PRODUCT / PROCESS CHANGE NOTIFICATION

1.1 Company		STMicroelectronics International N.V
1.2 PCN No.		MDG/22/13539
1.3 Title of PCN		ST Shenzhen (China) Assy & Test line upgrade for CMOS F9V Automotive grade EEPROM products in SO8N
1.4 Product Category		CMOS F9V Automotive EEPROM product in SO8N M95M04-DWMN3TP/V
1.5 Issue date		2022-06-30

ST Shenzhen (China) Assy & Test line upgrade for CMOS F9V Automotive grade EEPROM products in SO8N

- BOX LABEL MARKING

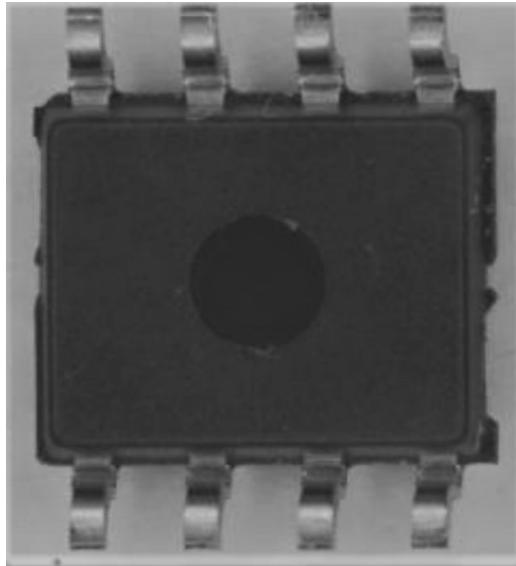
On the BOX LABEL MARKING, the difference is visible inside the **Finished Good Part Number** where the “**Assembly and Test & Finishing plants**” identifier is “**H**” for products **assembled & tested on SHD line**, this digit being “**G**” for current products assembled & tested on HD line.

Assembly and Test & Finishing plant:

- “0” for SHD line
- “G” for HD line

Package of SHD line

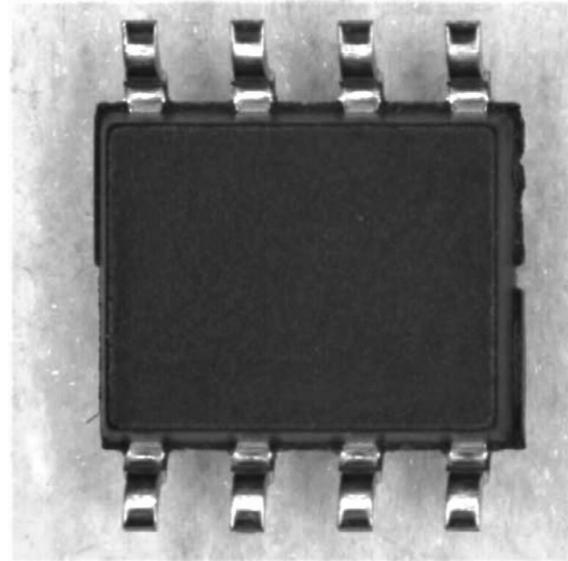
A visual difference can be observed at bottom side: the **package of the SHD line** is showing a **dot at the center** while no dot at bottom side on the package of the HD line:

Appendix B: HD / SHD flows comparison:Assembly flow comparison

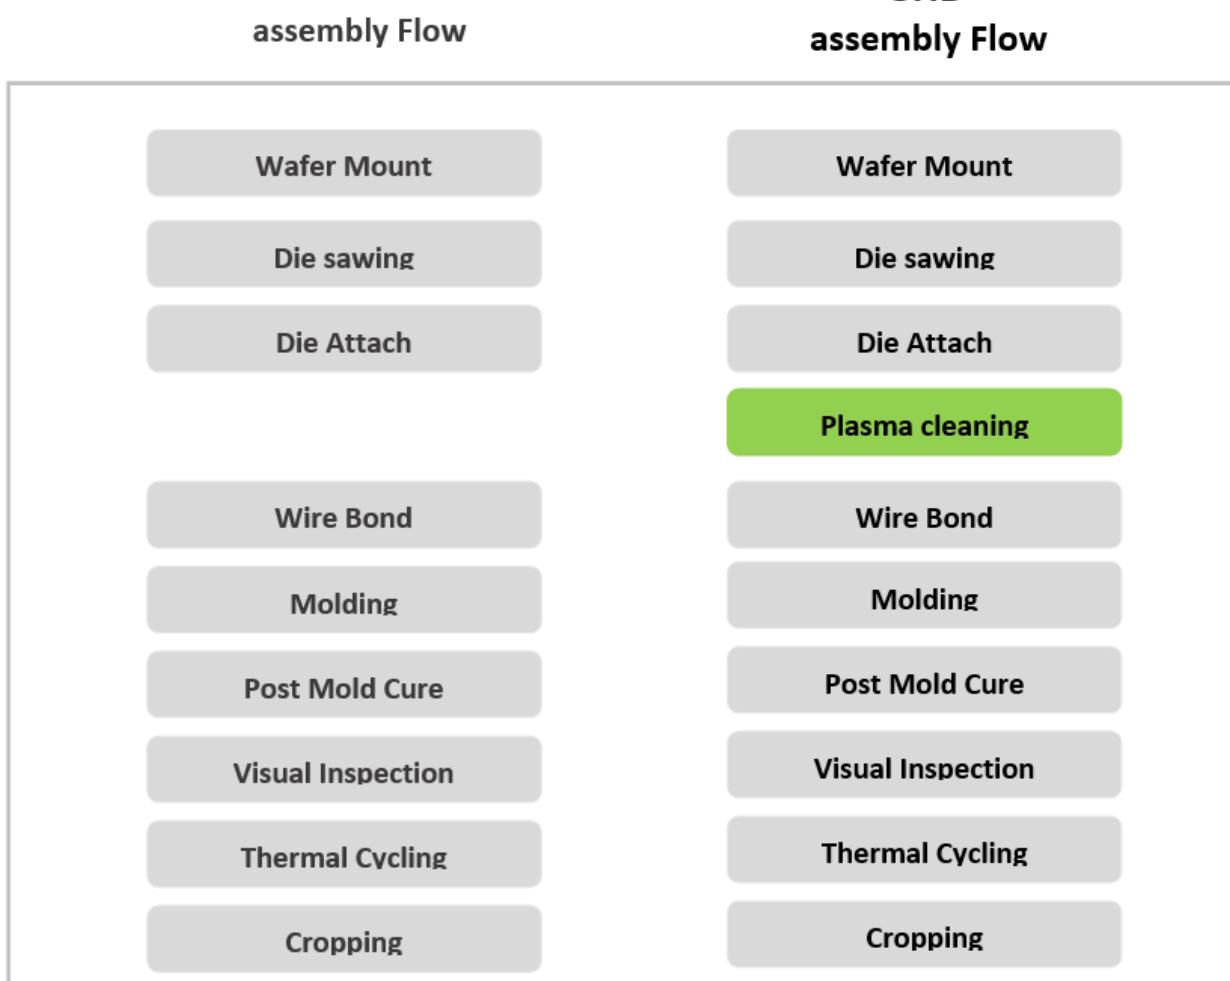
SHD Assembly line runs with higher parallelism and same assembly flow as current HD line. As continuous improvement, a step of plasma cleaning has been introduced between die attach and wire bonding.

Strip	HD Test line	SHD Test line
Size	32 x 8	36 x 12
Unit Qty / strip	256	432
Tester	Magnum-sv	Magnum-sv
Handler	MCT-tri-temp MCT SH5000	MCT-tri-temp MCT SH5000
Test parallelism	128	144
